# Access Compliance Report

## Public Rights-of-Way

### (Curb Ramps)

Intersection ID: 11824	Main Street: W_8TH_ST	Cross Street: N_CHURCH_ST	Location: S
ADA ID: EFE6B6000394	Ramp Type: PerpDiag	Initial Pass/Fail: Fail	Overall Compliance: No
Severity Score: 1.25			
Codes/Mitigation Info/Possible Solution		Field Measurements/Component Compliance

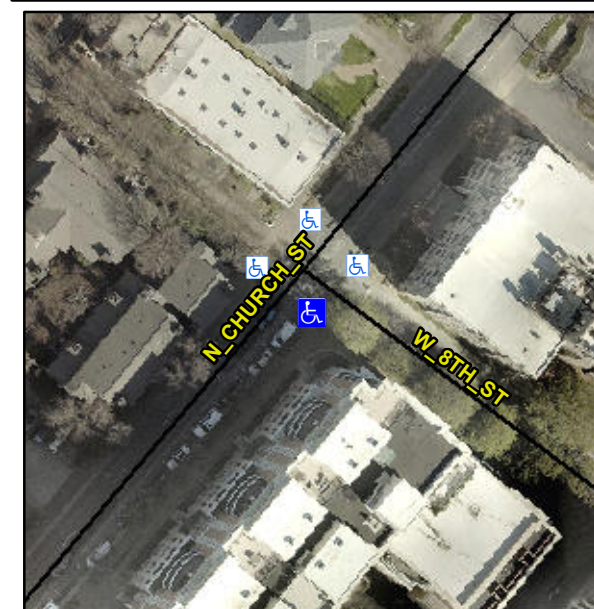
**Not Found, R304.5.3**

Compliance	Description	Data	Compliance	Description	Data
N/A	Ramp Length (in)	52.0	Yes	Ramp Slope (%)	5.7
Yes	Ramp Width (in)	48.0	No	Ramp XSlope (%)	3.1
N/A	Flare Type LT	N/A	N/A	Flare Type RT	N/A
N/A	Flare Slope LT (%)	N/A	N/A	Flare Slope RT (%)	N/A
N/A	Flare Traversable LT?	N/A	N/A	Flare Traversable RT?	N/A
N/A	Landing Length (in)	N/A	N/A	DWS Provided?	N/A
N/A	Landing Width (in)	N/A	N/A	DWS Contrast?	N/A
N/A	Landing Slope (%)	N/A	N/A	DWS Length (in)	N/A
N/A	Landing X Slope (%)	N/A	N/A	DWS Full Width?	N/A
N/A	Landing Curb? (Y/N)	N/A	N/A	DWS Offset (in)	N/A
N/A	Shared Landing?	N/A			
N/A	Gutter Ponding?	N/A	N/A	Gutter Slope (%)	N/A
N/A	Gutter Lip Ht (in)	N/A	N/A	Gutter X Slope (%)	N/A
N/A	Painted X Walk1?	No	N/A	Painted X Walk2?	No
	X Walk 1 Direction	To NE		X Walk 2 Direction	To NW
N/A	X Walk 1 Width (in)	N/A	N/A	X Walk 2 Width (in)	N/A
	X Walk 1 Slope (%)	4.8		X Walk 2 Slope (%)	1.9
	X Walk 1 X Slope (%)	2.0		X Walk 2 X Slope (%)	1.2

**Remove & Replace Curb Ramp With Two New Directional Ramps or Equivalent.**
